- 5. Pacific Park Subdivision 2024 Addition  
KPB File 2024-077  
Fineline Surveys, Inc. / Blauvelt  
Location: Whisky Gulch Street  
Anchor Point Area / Anchor Point APC**

**ITEM #5 - PRELIMINARY PLAT  
PACIFIC PARK SUBDIVISION 2024 ADDITION**

**STAFF REPORT**

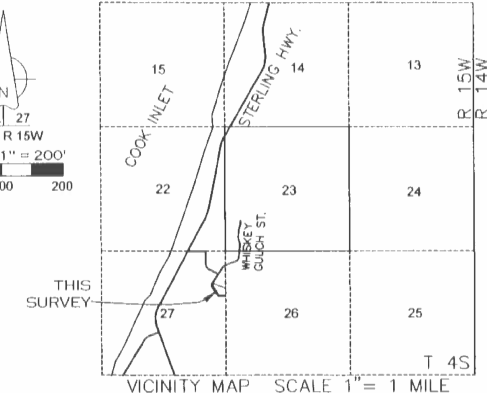
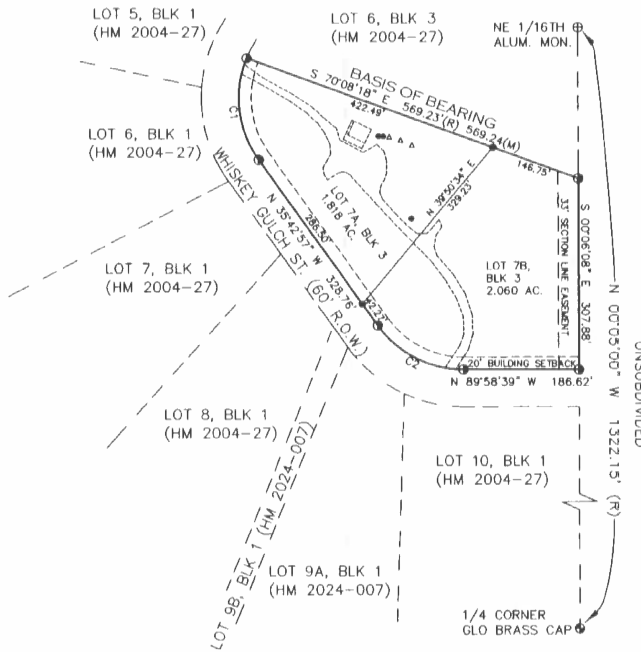
This plat is affected by a 33' section line easement which is shown on the drawing. **Staff recommends** the easement be extended to the north.

This area is covered by large portions of wetland classification from the Kenai Watershed Forum. Staff would like to remind the surveyor that approximate locations of low wet areas, areas subject to inundation are required on preliminary submittals. If showing the information makes information hard to read a supplemental map would suffice. **Staff recommends:** any wetlands or areas subject to inundation be shown on the final plat.

The River Center review has identified the plat to be located in a FEMA designated flood hazard area. Staff recommends per RC review that appropriate flood notes per KPB 20.3.280.D be added to the plat notes including the Flood Zone D and the FEMA Map Panel. A flood determination map has been included.

It is noted that a drive is shown crossing the plat and both lots. Staff recommends a joint access agreement be draw up when new ownership of one or both lots occurs, for use of the drive.

The parent plat, HM 2004-24, granted 10-foot utilities along all rights-of-ways and the correct note has been carried over. This easement should be shown on the drawing.

In the lots there are symbols that need to be removed or added to the legend.  
Tie the plat to the nearest BLM/ GLO corner.  
Carry forward plat note #2 from the parent plat.  
Plat note #7 can be removed as this is more of a flag lot issue note.  
The icons in the legend near the top need to be moved up to line with the labels.  
Add to the KPB File # 2024-077  
Add recorded data to the rest of plat other than just the north line.  
Add Surveyor's Certification to the drawing

- D. A vicinity map, drawn to scale showing location of proposed subdivision, north arrow if different from plat orientation, township and range, section lines, roads, political boundaries, and prominent natural and manmade features, such as shorelines or streams;  
**Staff recommendation:**  
Add road names to get to site  
Darken site location
